# CITY OF BLOOMINGTON

## PLAN COMMISSION

**BLOOMINGTON PLAN COMMISSION  
STAFF REPORT  
Location: 409 E Kirkwood Ave**

**CASE #: SP-25-22  
DATE: June 12, 2023**

409 E KIRKWOOD AVENUE  
SOUTH ELEVATION SCALE: 1/8" = 1' - 0"

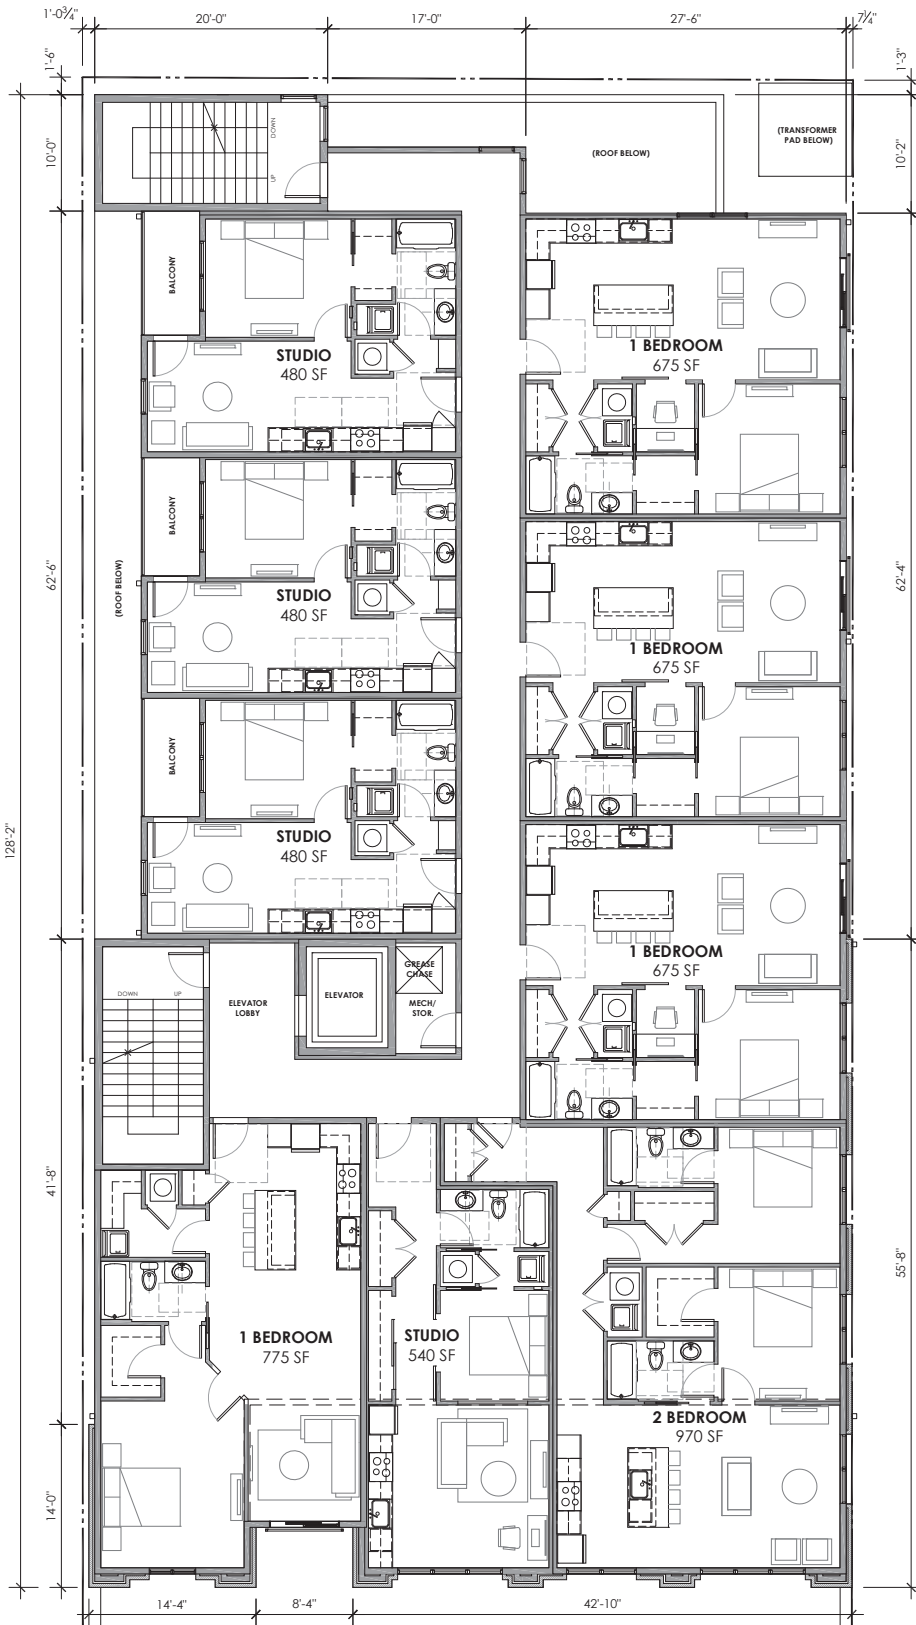
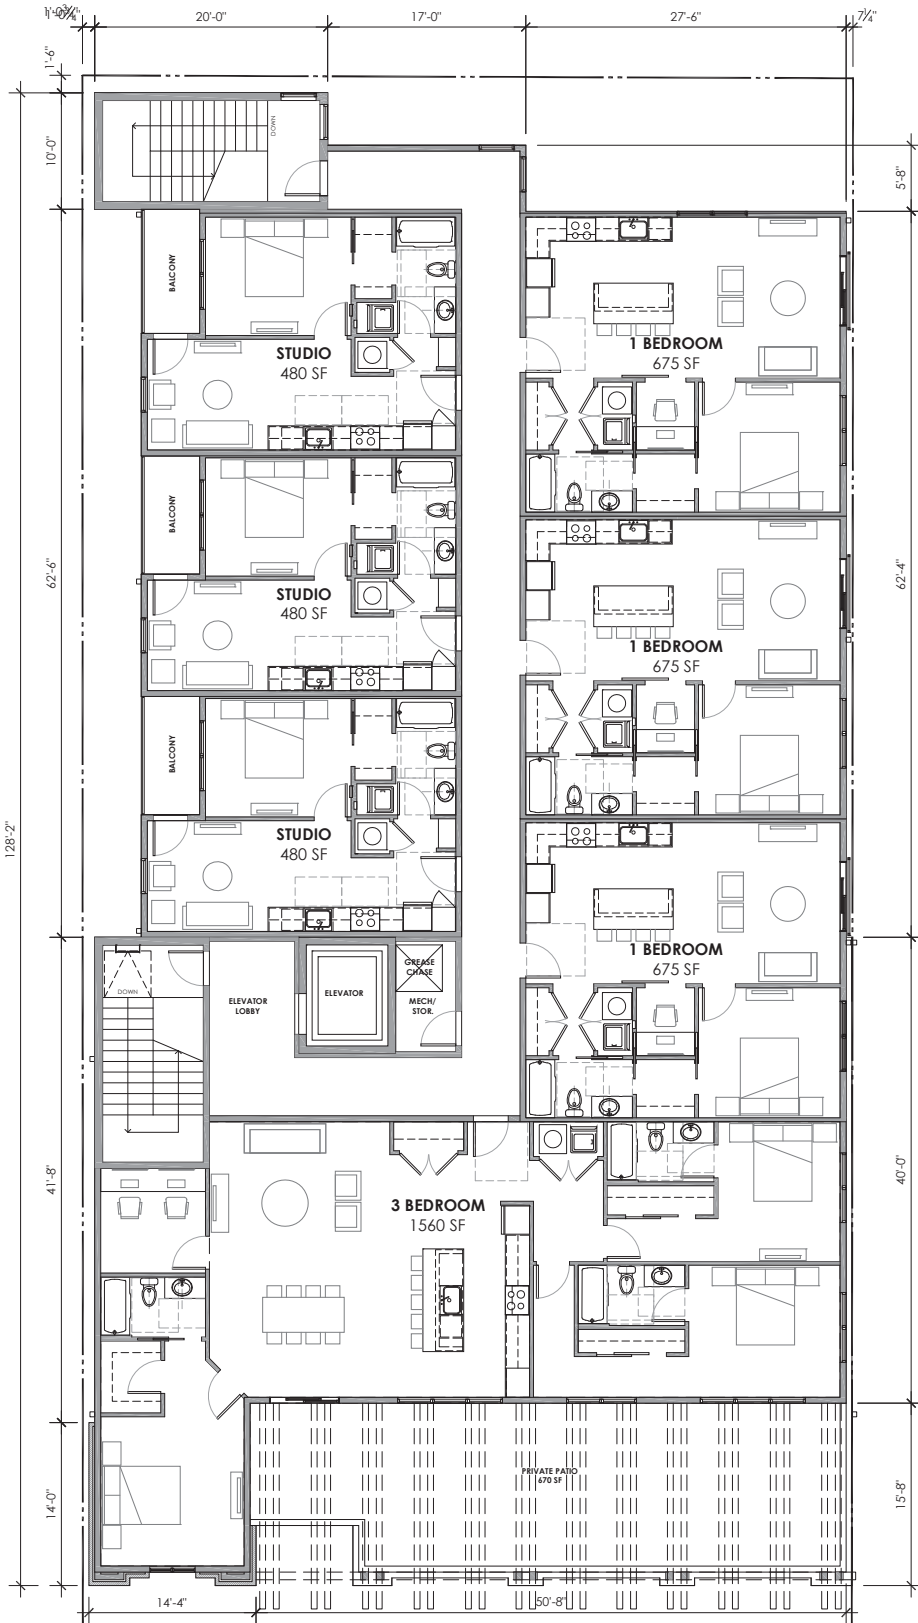
- **Setbacks:** The MD-UV zoning district requires a 0-15 foot build-to range with a minimum of 70 percent of the building façade at the build-to range, and a front parking setback minimum of 20 feet behind the primary structure’s front building wall. The proposed site plan demonstrates compliance with setbacks.

- **Height:** The maximum height in the MD-UV zoning district is three stories not to exceed 40 feet. The minimum floor to ceiling height on the ground floor shall be 12 feet because a nonresidential use is proposed. The proposal includes sustainable development incentives to add a fourth floor for a maximum height of 52’. The proposed height is 50’10” and meets the maximum height requirement with incentives.

- **Windows and Doors on Primary Facades** – In the Kirkwood Corridor, at least 60 percent of the total façade area of the first floor shall incorporate transparent glass or framed façade open areas consisting of display windows, entries and doors. The proposal meets this standard.

- **Exterior Facades** – The UDO requires that all facades incorporate at least three design elements every 40 feet to break up monotony. The proposal includes metal awnings, change in building façade heights by at least five feet, and wall elevation projections by at least three percent of façade widths.

**Screening** – Ground-mounted mechanical equipment, including transformers, shall be located where it is not visible from public open space, public trails, public streets, or from adjacent properties to the maximum extent practicable. In cases where the equipment is visible, it shall be screened from view by a solid wall or fence or a vegetative screen. The proposal includes a transformer located up to the property lines in the northeast corner of the property. The petitioner has expressed concern that there is not enough space to provide screening along the sides facing the alleys. The petitioner must file for a variance from the screening requirements. A condition has been added.

1. The petitioner must obtain a grading permit before earth moving.
2. The petitioner must revise the frontage zone such that more space can be dedicated to the sidewalk to meet the minimum 10-foot width per the Transportation Plan.

5. The petitioner must file for a variance from the ground-mounted mechanical equipment screening standards.
6. The petitioner must provide information about the outdoor lighting fixtures.
